REVISION #1 09/16/2024
REVISED SHEETS: EC1-EC3, U1-U3, U6, U7
REVISION #2 02/28/2025
REVISED SHEETS: EC1, PD4, P4, U4, S1, S2, S3, S6 - new sheet, X8, X9
REVISION #3 04/25/2025
REVISED SHEETS: PD3, P3, X5, X6
REVISION #4 04/28/2025
EVISED SHEETS: G11, G12, G14 - new sheet, PD3, P3, P4, P6, U3, U6, X4, X5

PLAN OF PROPOSED IMPROVEMENT

KNUTSON DRIVE AND GREEN AVENUE ASSESSMENT DISTRICT - 2024

CITY PROJECT NO. 13812
CONTRACT NO. 8635

EC-4

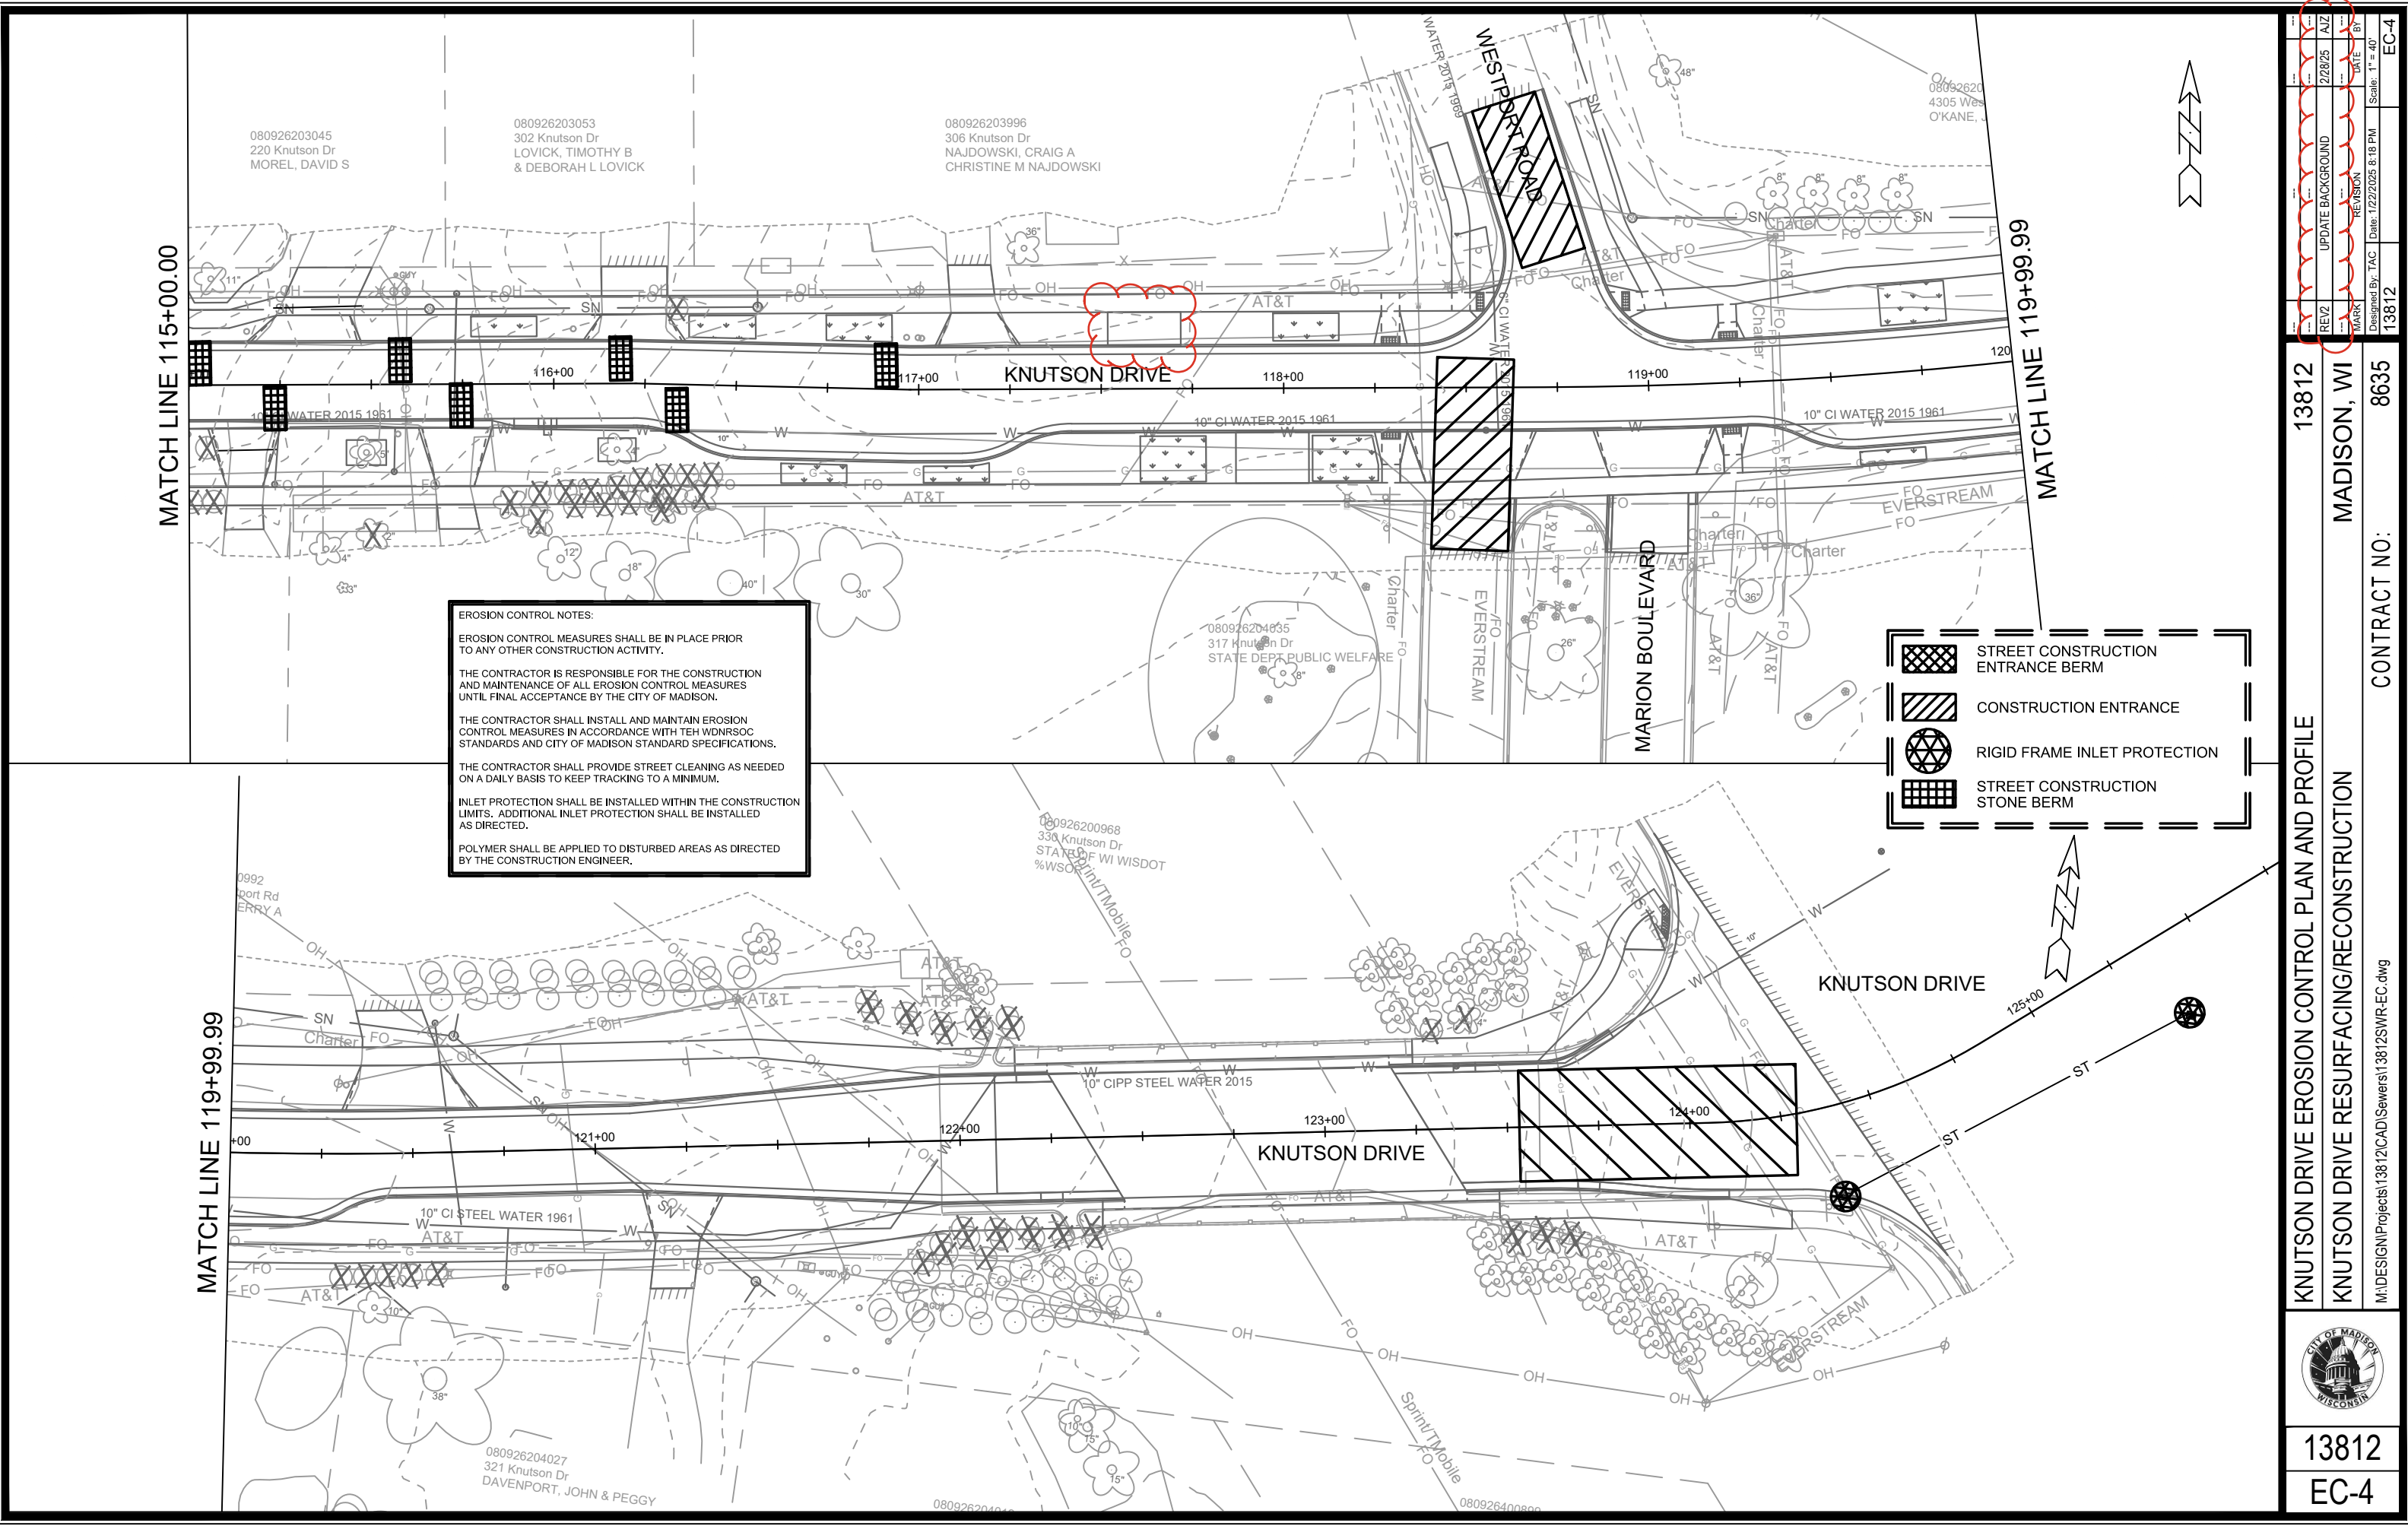
REV 4: UPDATED CURB AND
FLUME ELEVATIONS

GI-1

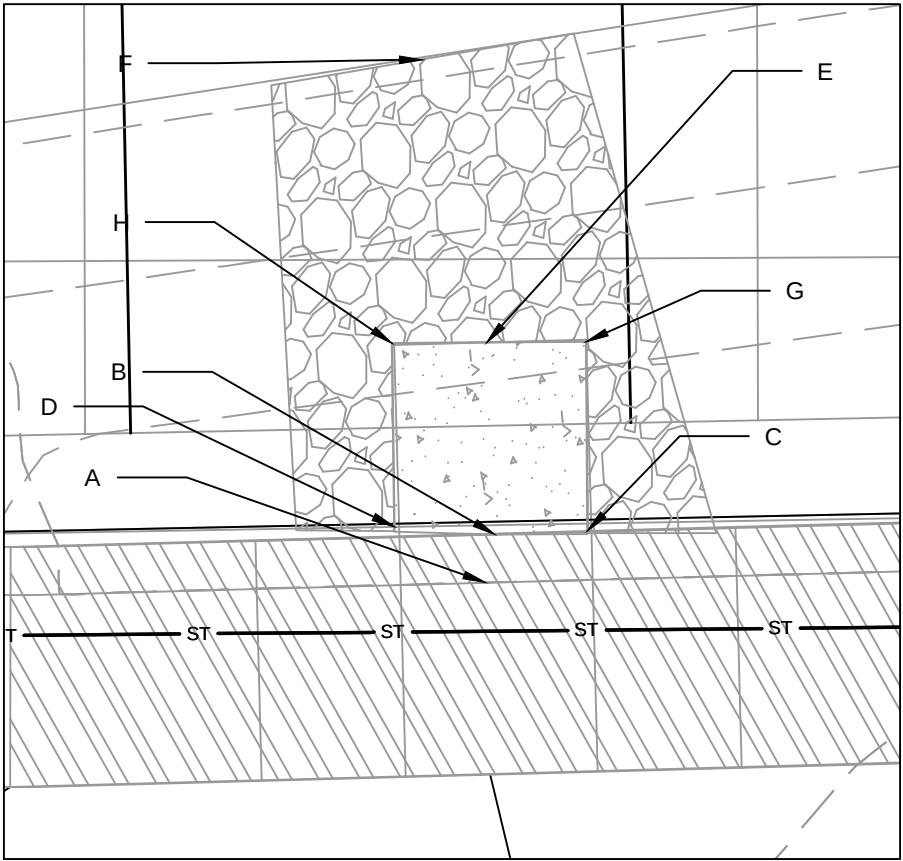
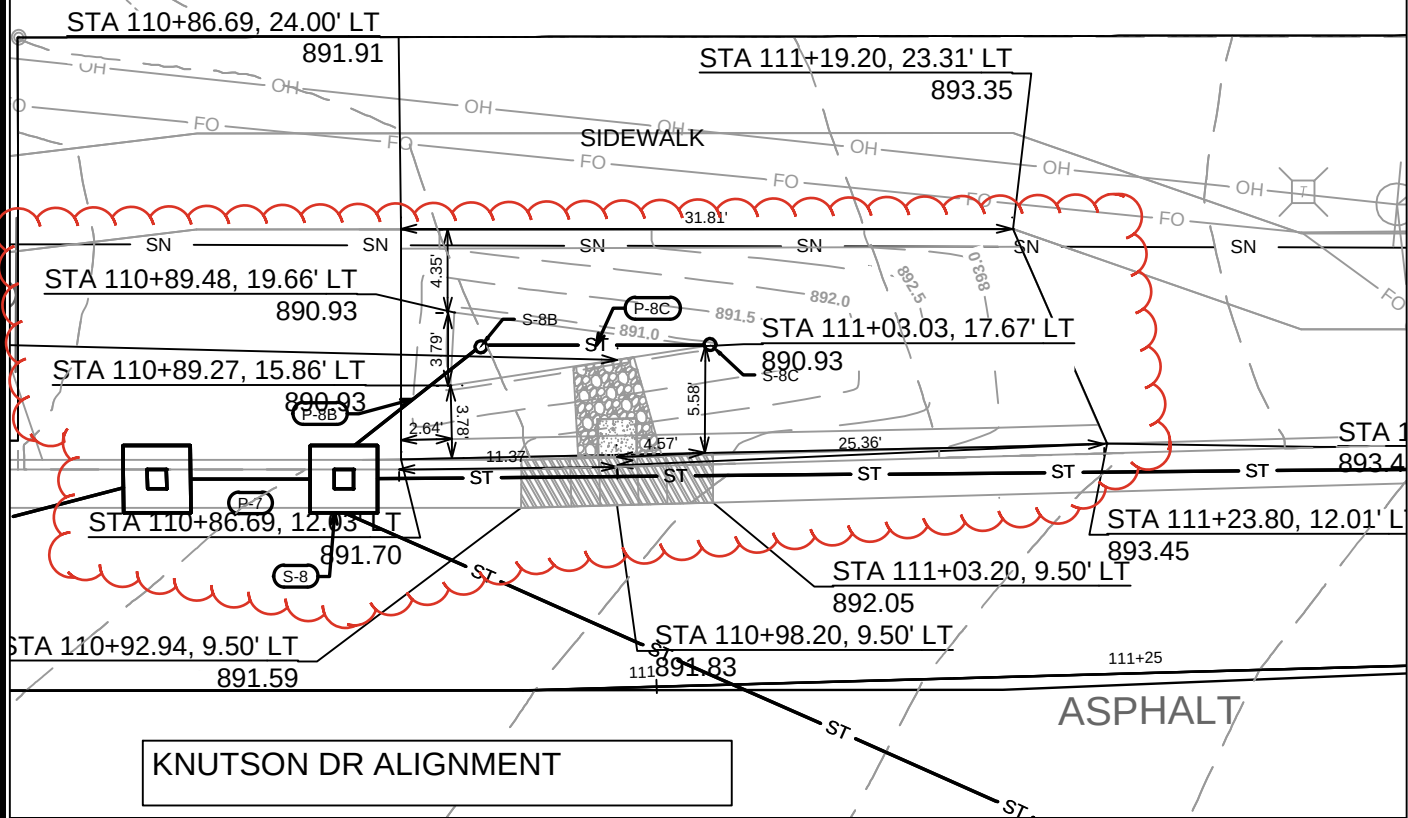
REV 4 | G1 GRADE ADJUSTMENT AND ADD 209 RG 04/28/25

REVISION 4: ELEVATION CHANGES TO CURB AND FLUME, ADJUSTMENTS TO CURB SIDE BIORETENTION GRADES

080926204077
209 KNUTSON DR
HANNAH, RICHARD M
MARGARETE HANNAH

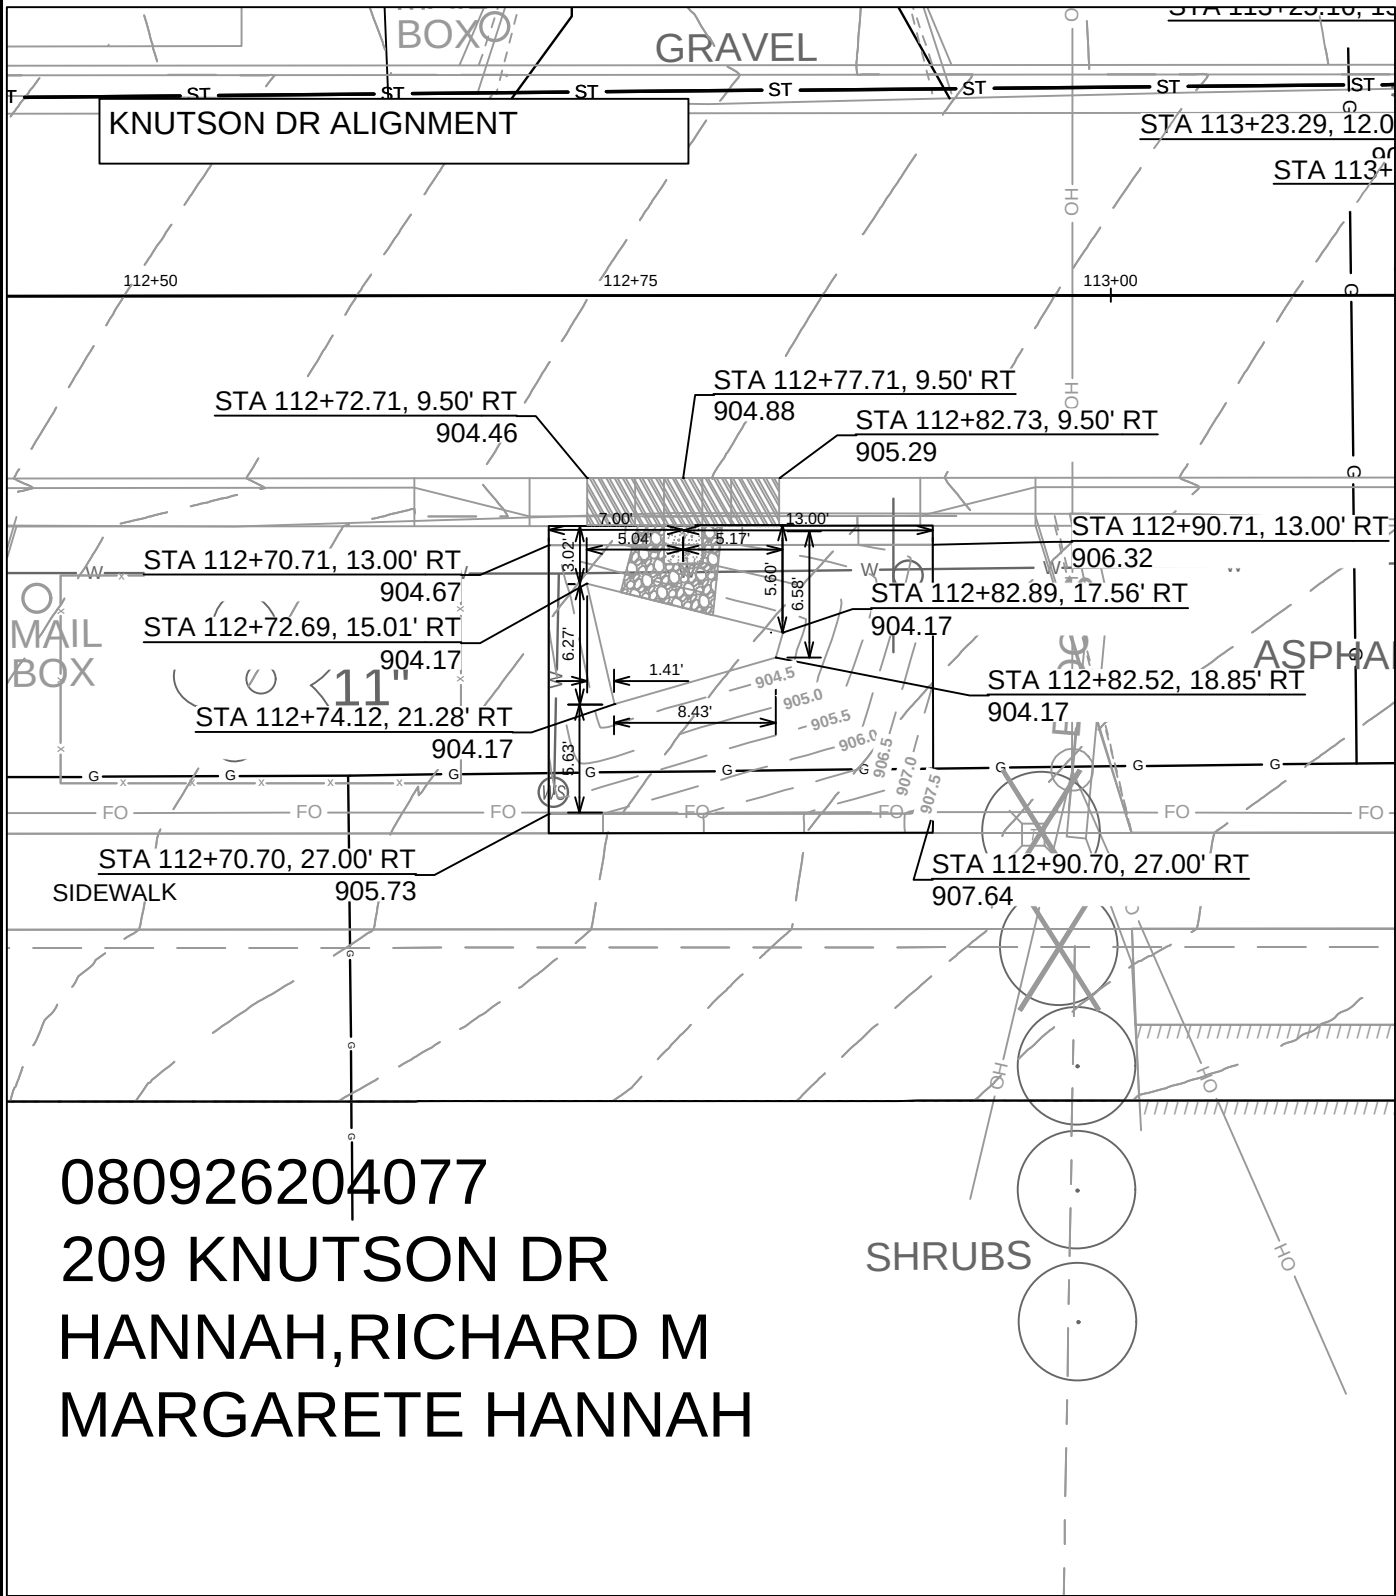
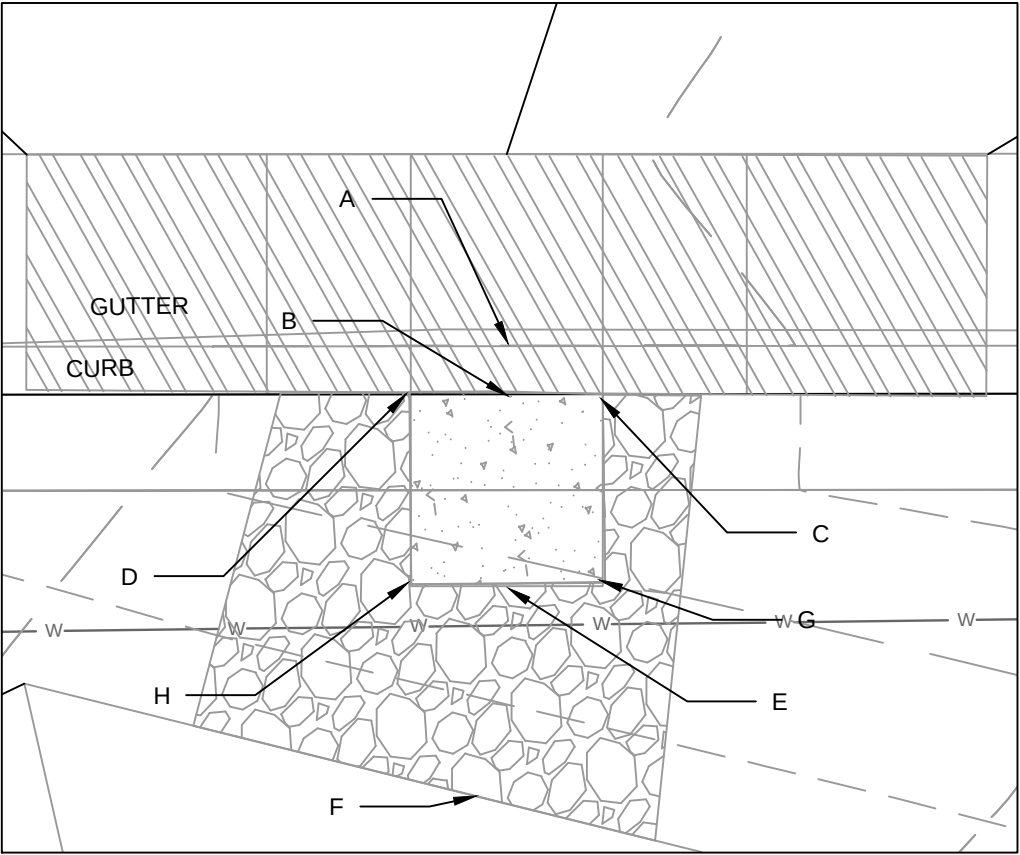
REVISION 4: NEW SHEET FOR RAIN GARDEN AT 209 KNUTSON
